Design Review Committee Meeting

June 16, 2021 6:00 PM

**DEPARTMENT OF PLANNING AND ZONING
PLANNER'S REPORT**

DATE: June 11, 2021
TO: Tonya Hutson
FROM: Lynn Patterson
RE: **Design Review – 3571- 3581 South Fulton**

DATE:

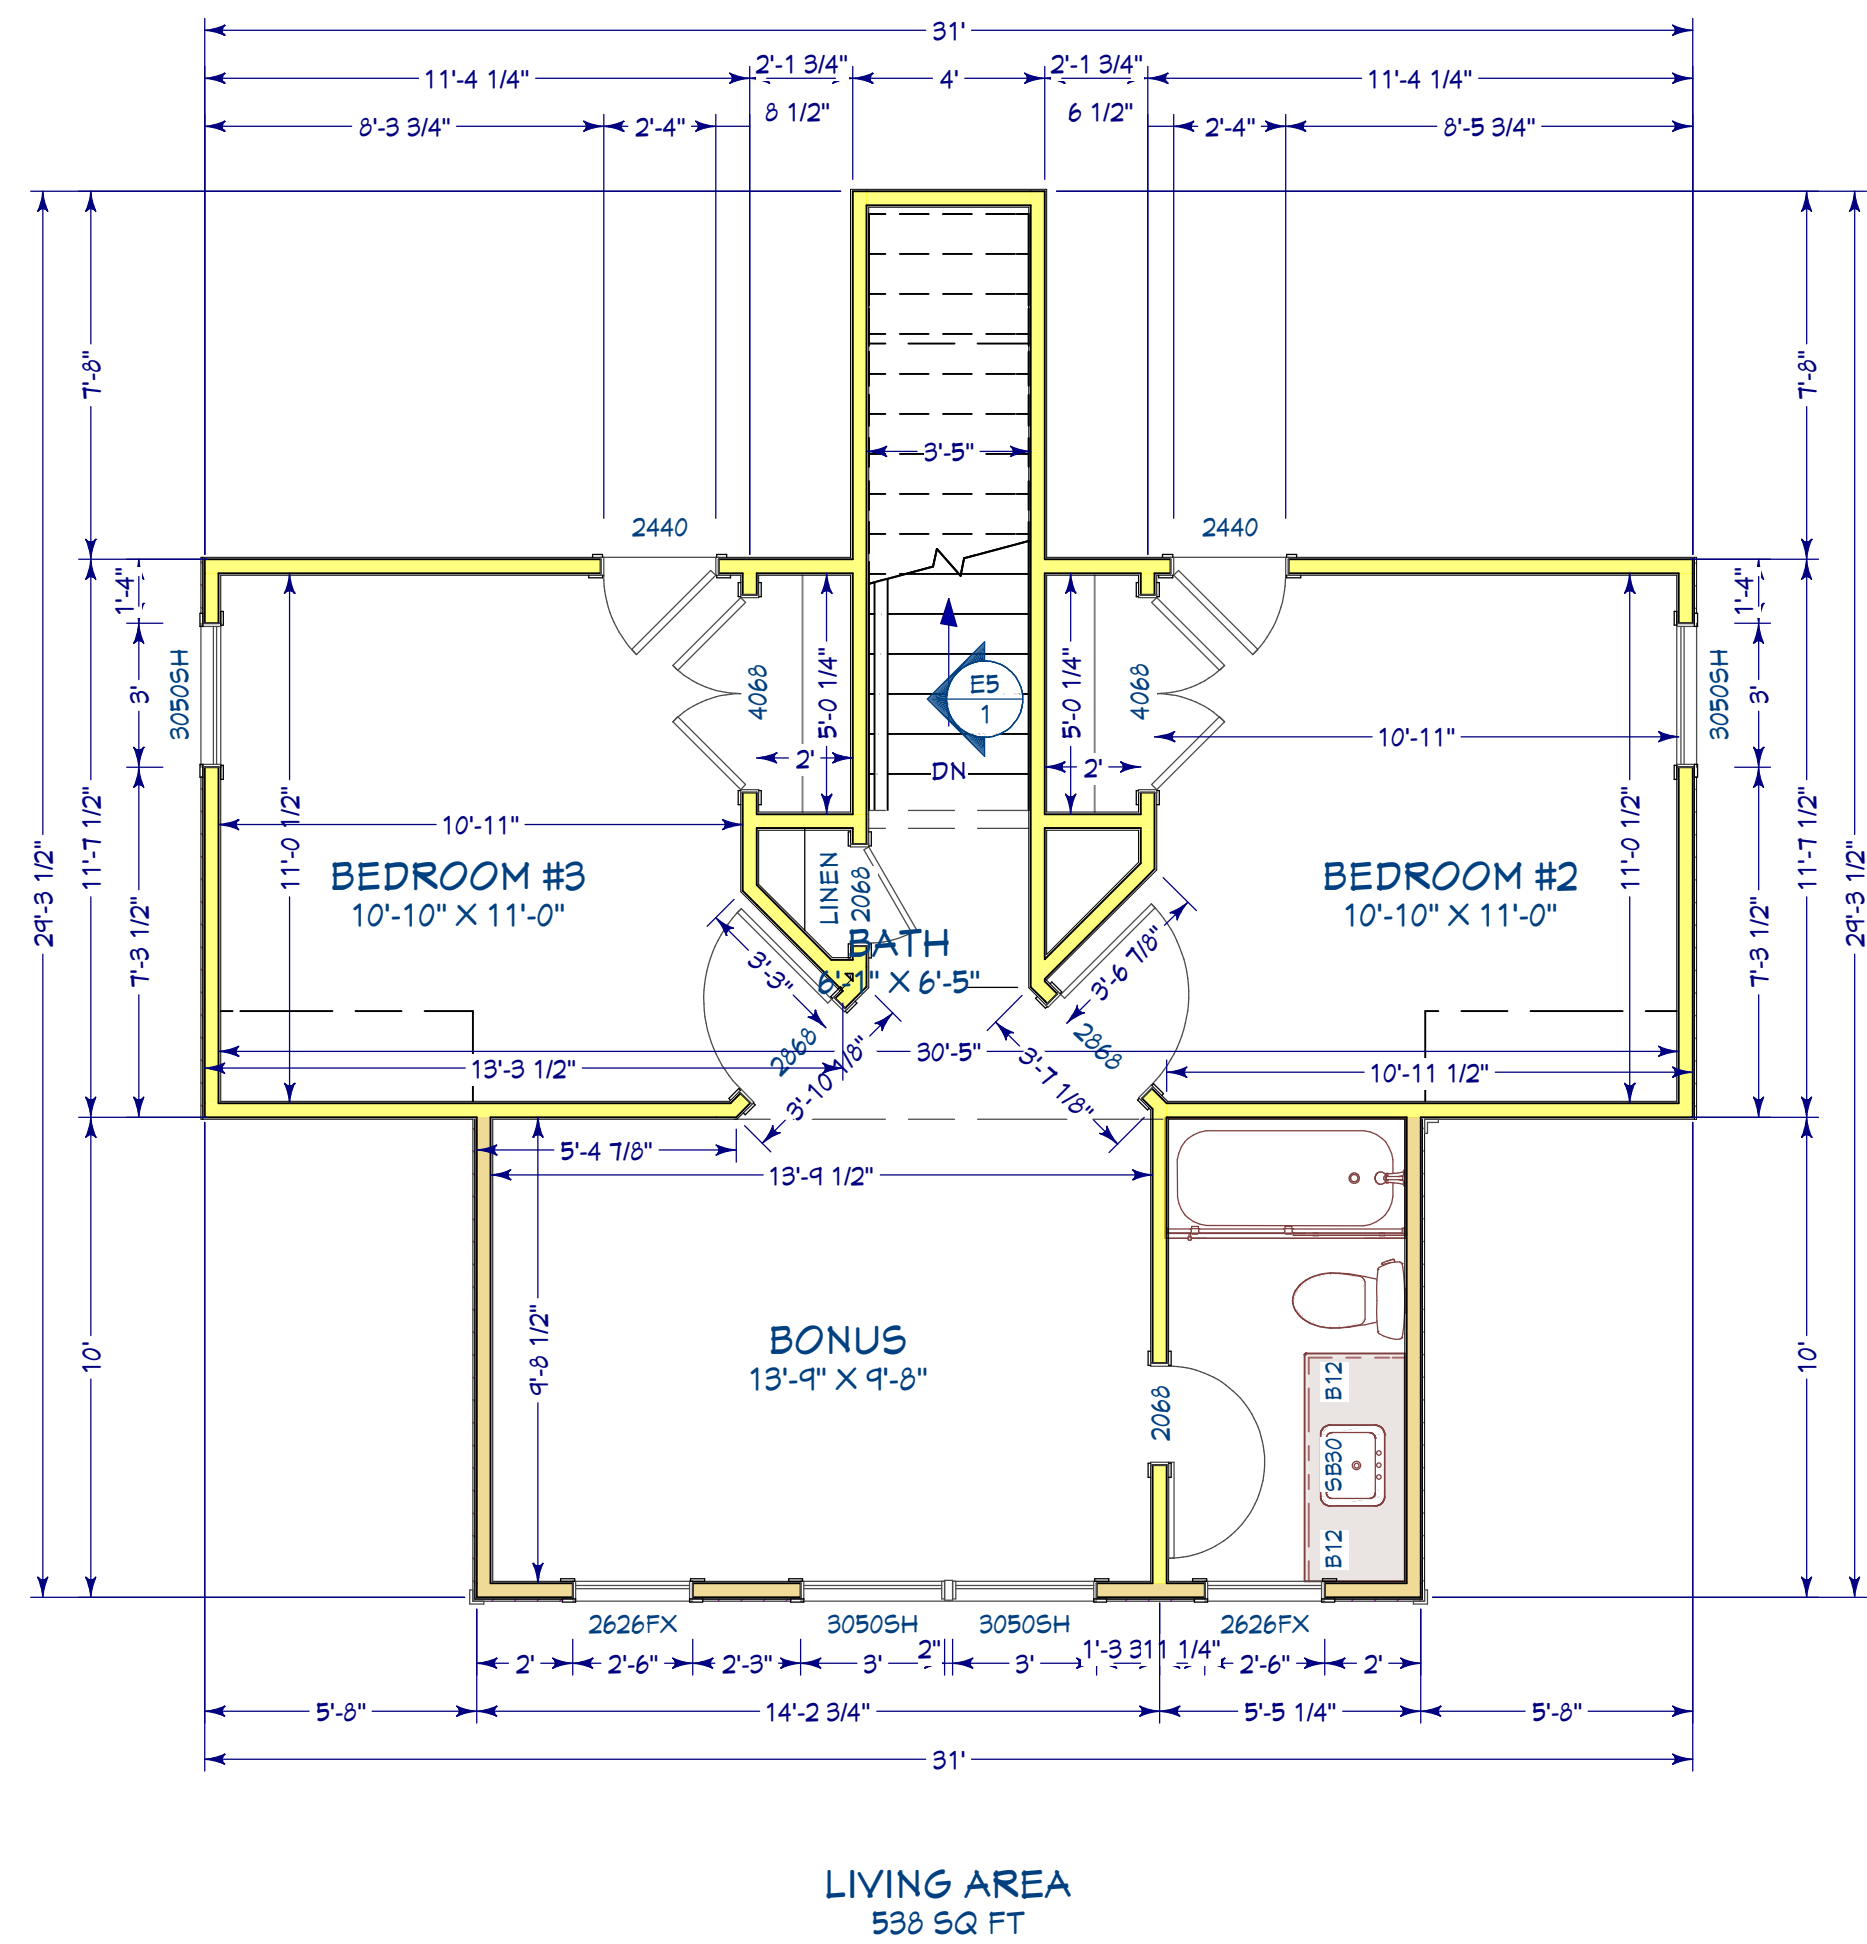
STAFF COMMENT: Ensure mechanical is screened. Ensure front door light is provided.

STAFF COMMENT: Downspouts are not shown.

STAFF COMMENT: All wood must be painted or stained on porches. Foundation should be enclosed. Depth of porch is 7' not 8'.

STAFF COMMENT: Building numbers should be provided. Trim detail should be provided.

STAFF COMMENT: *Provide sill height.*

- Porch should be 8' to meet Standards.
- Downspout locations
- Mechanical screening
- Paint or stain on porches
- Building numbers
- Trim detail to meet standards
- Light at front porch
- Porch foundation enclosure
- Sill height to meet standards
- Approved Tree Conservation Plan (finalize with Arborist)
